Title: "DEVICE AND METHOD FOR TRENCHLESS REPLACEMENT OF

UNDERGROUND PIPE"

PRELIMINARY AMENDMENT

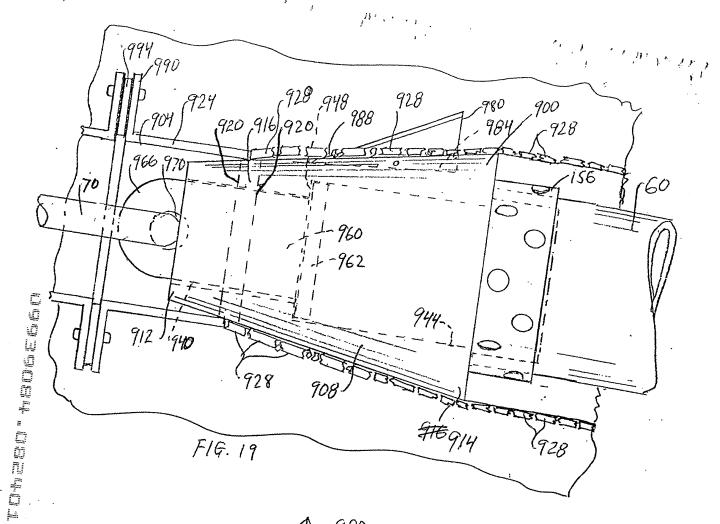
Fig. 19, please add the number 944. This change corresponds to the specification, page 22, line 2.

Fig. 19, please change 916 to 914 as shown in red. This change, and a change in the specification, page 21, line 15, is made in that a duplicate numeral 916 which relates to the pipe engagement region is found in Fig. 19 and described on page 21, lines 16-18.
